KANSAS STATE UNIVERSITY  
TRIGA MARK II NUCLEAR REACTOR FACILITY  
LICENSE NO. R-88  
DOCKET NO. 50-188

SAFETY ANALYSIS REPORT  
DATED 21 DECEMBER 2004

**RE: Additional Information Relative to License Renewal of the Kansas State University Nuclear Reactor Facility (License R-88, Docket 50-188)**

The attached material includes (1) a revision to the proposed Safety Analysis Report (addressing both relevant informal recommendations and the Request for Additional Information) , and (2) a tabulation of revisions and a tabulation of how each RAI item was addressed.

Figure 5.4: Cooling Tower

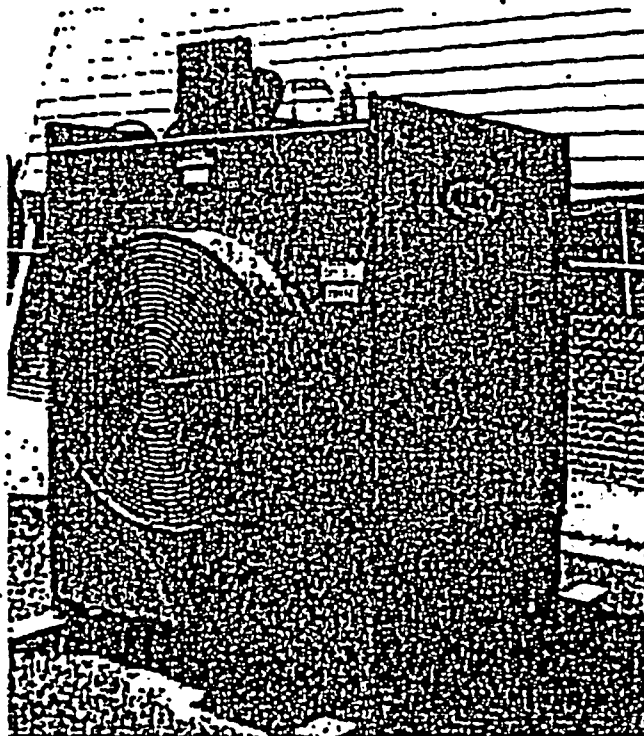
the tank....				
5-4	5.3	Cooling tower capacity was upgraded	5-4	5.3	The secondary cooling system is designed for continuous operation at approximately 723 kW.	Clarification
5-6	5.3.1	The water from the surge tank is then drawn into the system by a direct-coupled, self-priming, centrifugal pump (see Figure 5.3). When the controls are in a normal configuration, the pump is energized (with the primary pump and cooling tower fans) from a backlit push button switch in the control room. Normal flow rate through the system is 176 gallons per minute (11.1 L·s <sup>-1</sup> ).	5-6	5.3.1	The water from the surge tank is then drawn into the system by a direct-coupled, self-priming, centrifugal pump (see Figure 5.3). When the controls are in a normal configuration, the pump is energized (with the primary pump and cooling tower fans) from a backlit push button switch in the control room. Normal flow rate through the system is 250 gallons per minute (15.8 L·s <sup>-1</sup> ).	Equipment modification

Normally, water leaving the heat exchanger is then sent to the cooling tower (Figure 5.4) and returned to the surge tank. However during cold weather conditions (when outside air is less than  $-10 \text{ }^\circ\text{F}$ ,  $-23 \text{ }^\circ\text{C}$ ), the water bypasses the cooling tower at a three-way valve and is returned directly to the pump. Any water in the cooling tower then drains into the surge tank. The cooling tower is an induced-draft, crossflow design constructed of galvanized steel with a 146-ton cooling capacity. It is located outside the reactor building, outside a fenced area at about the 12-foot level of the reactor. The tower contains 142 gallons (538 L) of water during operation. It has a two-speed fan controlled by the secondary automatic control system. The tower was replaced along with the surge tank in 1991. The tower was upgraded in 2001 to permit 500 kW operations.

Figure 7.2, USGS TRIGA Console with Modifications.

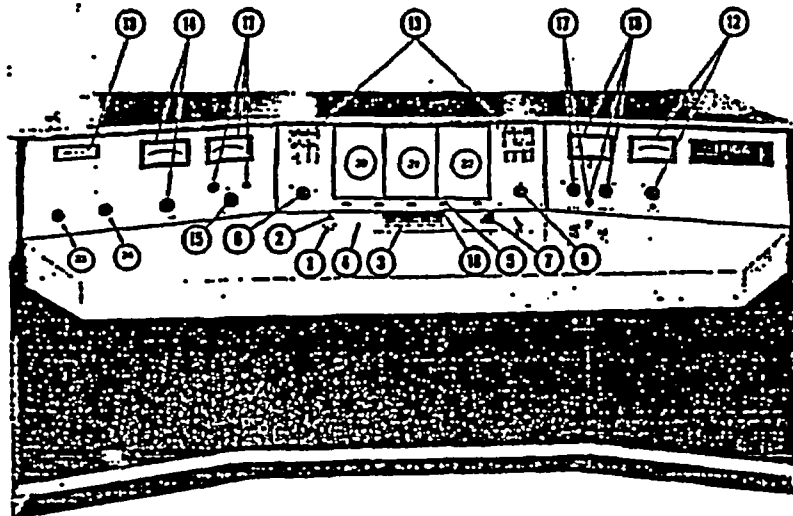
7-5	7.2.3	The overall system layout is depicted in Figure 7.2. The majority of the RCS is housed in a General Atomics (GA) console originally manufactured for the USGS reactor, which is shown with modifications in Figure 7.2. A detailed description of this figure is provided	7-5	7.2.3	The overall system layout is depicted in Figure 7.2. The majority of the RCS is housed in a General Atomics (GA) console originally manufactured for the USGS reactor, which is shown with modifications in Figure 7.2. A detailed description of this figure is provided in Table 7.1. Figure 7.3 shows a representative layout of the auxiliary instrumentation rack.	Clarification
7-6	Fig 7.3	Labels changed	7-8	Fig 7.3	Timer & Pool Light controls removed	Equipment modifications
7-7	Table 7.1, No. 13	Scram Status, Source Interlock, Low Air Pressure, Person on Stairway, Upper & Lower Doors, and Cooling System Power	7-7	Table 7.1, No. 13	Scram Status, Source Interlock, Low Air Pressure, Hi & Hi-Hi sump level, surge tank level & makeup, Upper & Lower Doors, and Cooling System Power	Equipment modifications

The overall system layout is depicted in Figure 7.2. The majority of the RCS is housed in a General Atomics (GA) console originally manufactured for the USGS reactor, which is shown with modifications in Figure 7.2. A detailed description of this figure is provided in Table 7.1. Figure 7.3 shows a representative layout of the auxiliary instrumentation rack. Since the instrument racks are general use equipment, configuration may be changed to allow better utilization of space, installation of new equipment, support specific equipment modifications, etc. without affecting function. The functions of each piece of equipment in this configuration are discussed in following sections with additional figures showing location and layout.

Figure 7.7, Control Rod Drive Circuit.

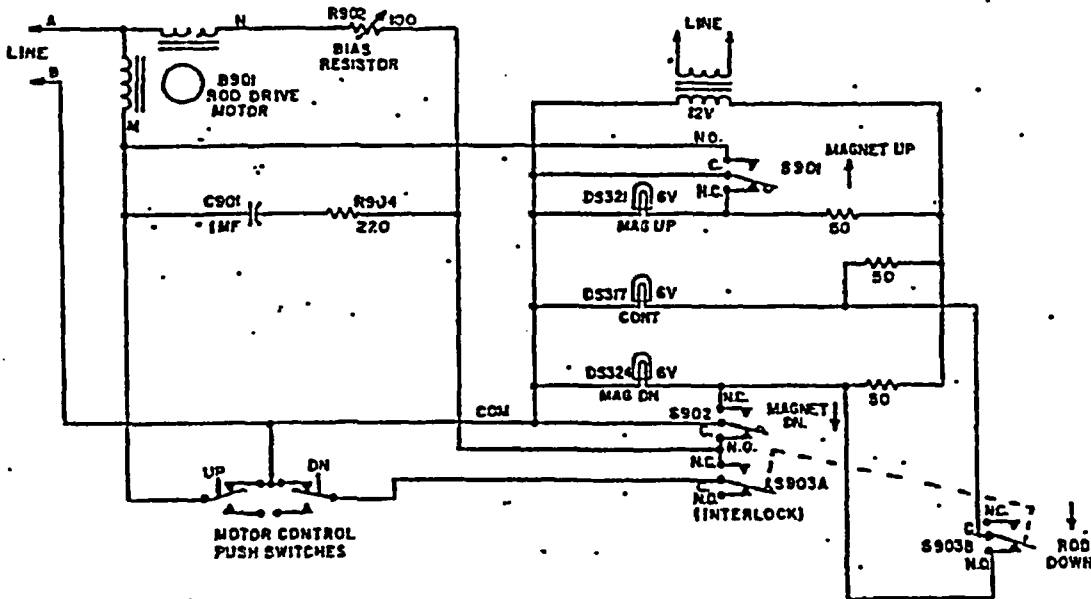
7-12	7.3.4.a	The rod drive motor is dynamically braked and held by an electrically locked motor. In the static condition, both windings are energized with the same phase (see Figure 7.7), electrically locking the motor. Clockwise (up) or counter-clockwise (down) rotation is enabled by shifting the phase between the windings with a 1- $\mu$ F capacitor; motor control switches allow the appropriate phase shift.	7-11	7.3.4.a	The analog rod drive motor is dynamically braked and held by an electrically locked motor. In the static condition, both windings are energized with the same phase (see Figure 7.7), electrically locking the motor. Clockwise (up) or counter-clockwise (down) rotation is enabled by shifting the phase between the windings with a 1- $\mu$ F capacitor; motor control switches allow the appropriate phase shift. The stepper motor operates using phase switched direct current power. The motor shaft advances 200 steps per revolution (1.8 degrees per step). Since current is maintained on the motor winding when the motor is not being stepped, high holding torque is maintained. A translator module drives the stepping motor.	RAI # 12, 13

The analog rod drive motor is dynamically braked and held by an electrically locked motor. In the static condition, both windings are energized with the same phase (see Figure 7.7), electrically locking the motor. Clockwise (up) or counter-clockwise (down) rotation is enabled by shifting the phase between the windings with a 1- $\mu$ F capacitor; motor control switches allow the appropriate phase shift. The stepper motor operates using phase switched direct current power. The motor shaft advances 200 steps per revolution (1.8 degrees per step). Since current is maintained on the motor winding when the motor is not being stepped, high holding torque is maintained. A translator module drives the stepping motor.

Figure 4.13, Axial Variation of fuel, cladding, and air temperature immediately following a loss of coolant accident, with equilibrium fission product heating.

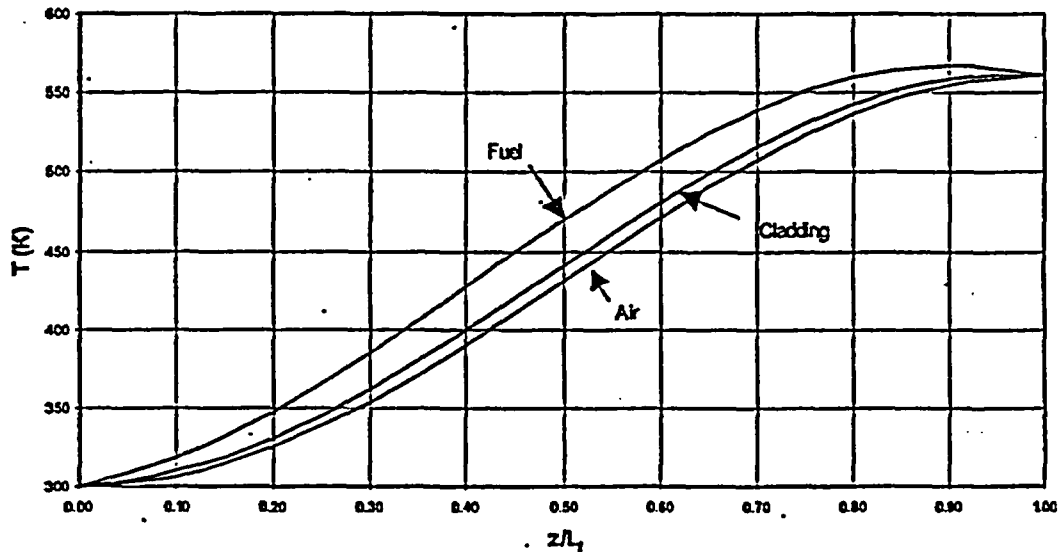
various	various	500 kW	various	various	1,250 kW	Power level for bounding analysis
13-8	13.2.2.e	Fuel and cladding temperatures are reported in Table 13.2 and illustrated in Figure 13.6 for the case of zero time post accident.	13-8	13.2.2.e	Fuel and cladding temperatures are reported in Table 13.6 and illustrated in Figure 13.2 for the case of zero time post accident.	Correct references
13-8	Table 13.6	Values for 500 kW	13-8	Table 13.6	Values for 1,250 kW	Power level for bounding analysis

Fuel and cladding temperatures are reported in Table 13.6 and illustrated in Figure 13.2 for the case of zero time post accident. This is based on three conservative assumptions: equilibrium fission product buildup at full power, instantaneous loss of coolant when the reactor scram occurs, and equilibrium temperature based on initial decay heat production.
